MJP Associates, Ltd.  
4362 Oakmede Lane  
White Bear Lake, MN 55110  
PH. 651-426-7037  
FAX 651-426-6643  
www.mjp-associates.com

Re: Structural Evaluation Column Bases @ West 7<sup>th</sup> Street Pharmacy, St. Paul  
MJP ASSOCIATES, Ltd., Project # 111102, Report #1

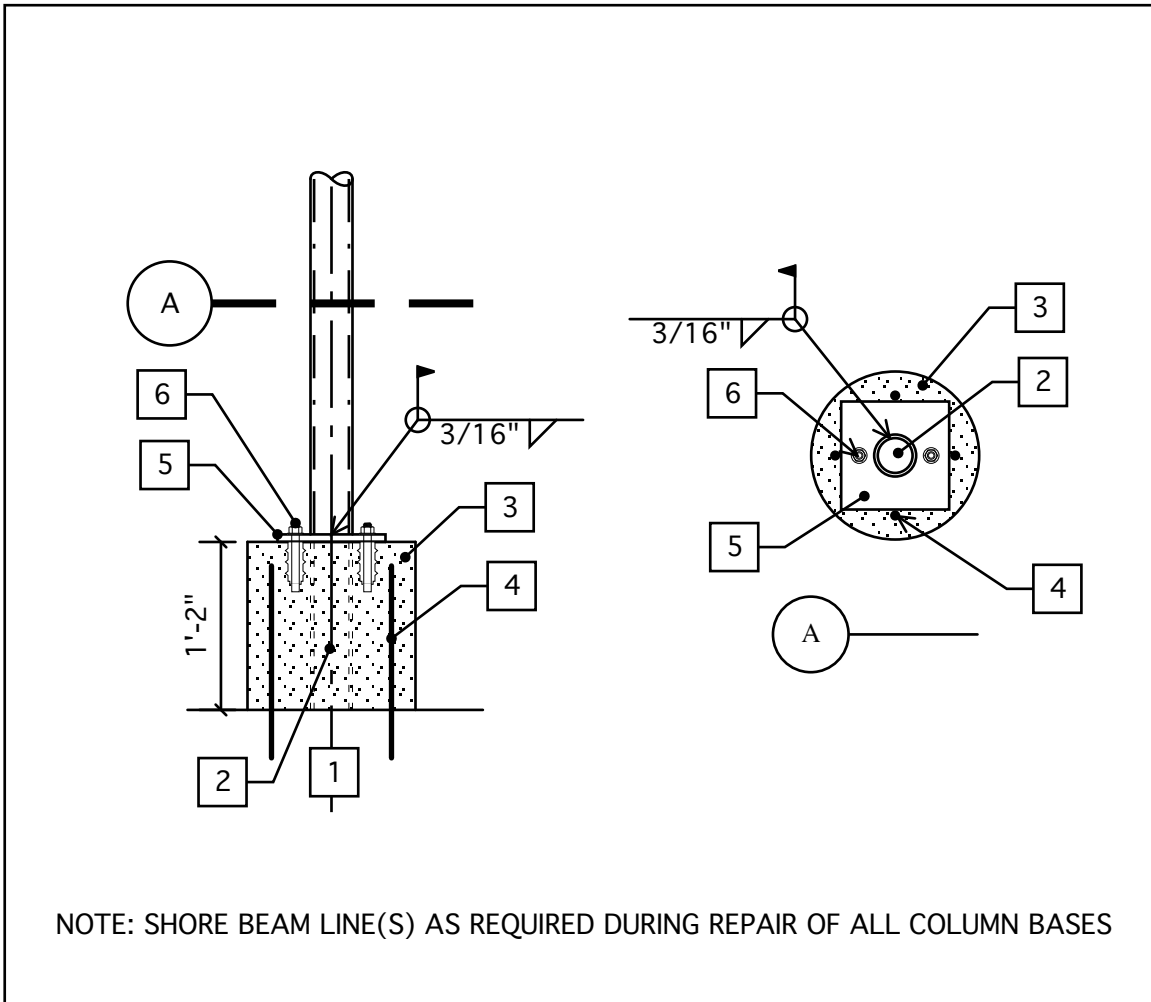
- 1) Remove the corrosion & refinish the base of the existing cast iron column with a rust inhibiting coating as required. (See Photos IMG\_0722 & IMG\_0724 in Field Report 1)
- 2) Cut off the bottom portion of all steel column ((5) total); provide new base plates; & provide new poured concrete bearing piers. See Detail 1

- 1) Existing Slab/Footing
- 2) Existing Pipe Column - remove bottom 14"; clean & remove rust debris@ existing column bearing as required to allow complete bearing between new pier & existing slab/footing.
- 3) New Plain Concrete Pier - 14"Ø x 14" high; f'c=4000psi in 28 days; 3000psi in 7 days
- 4) Dowels - (4) #5x16"; drill and grout into existing concrete a minimum of 4"
- 5) New Base Plate - 9x9x5/8 Fy=36000psi
- 6) Anchor Bolts - (2) 1/2"Ø Hilti KB3 - HDG; 2-1/4" embedment

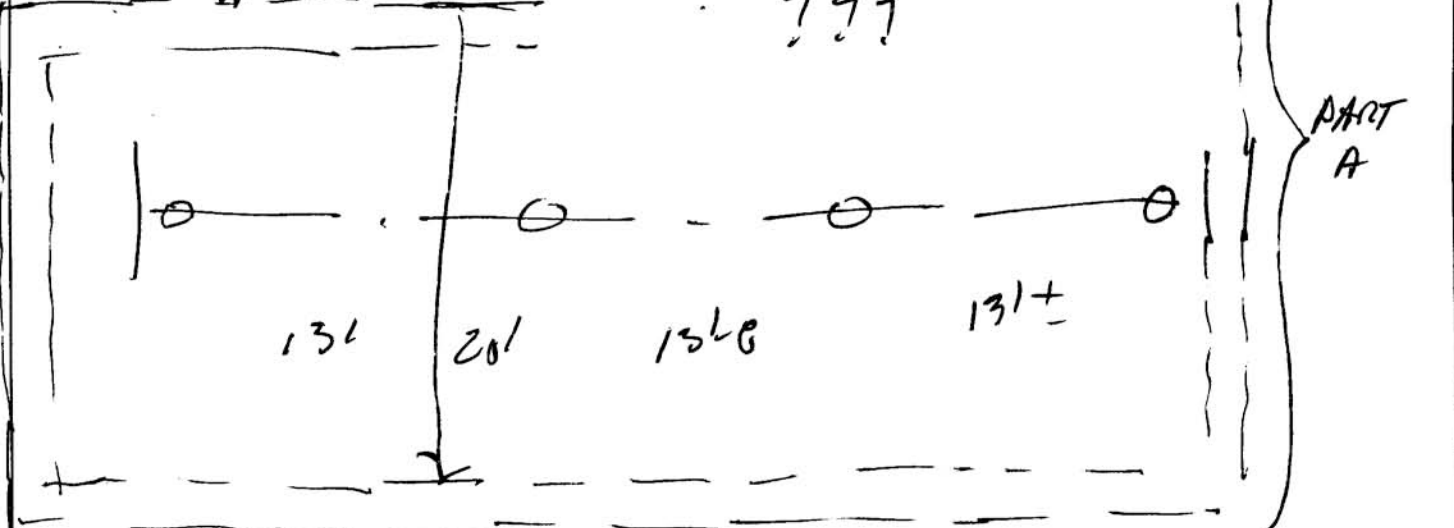
EXISTING CONDITIONS:  
 Col. 3 1/2" SWP 7 @ 6'-6"±

Beam 8 1/4" x 5 1/4" UP  
 0-1 Flange; 1 Web. W8x16  
 0.25 LF 10325 0.161

IMG\_0728

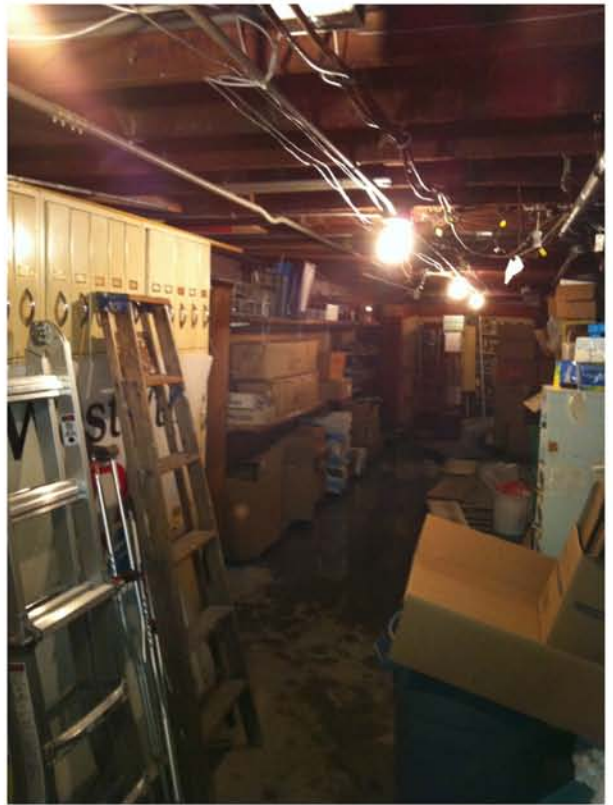
- Original Bldg was built in late 1800s, early 1900's.
- At some point it was moved to its current location
- There is standing water on the basement floor
- The beam in question does not appear to be part of the original building - See sheet 1 for dimensional information
- Pairs of (4) columns (Part A) & (2) columns Part B are rusted.
- It is not known at the time of this report how hard the current columns are working
- Repair options discussed:
  - (1) a) Four new pier  $\sim 12'' - 14'' \square$  or  $\circ \sim 14''$  high.
    - b) Attach new base plate @ top of new pier
    - c) Clean up rusted portion of column & base plate
  - 2.) T.B.D.
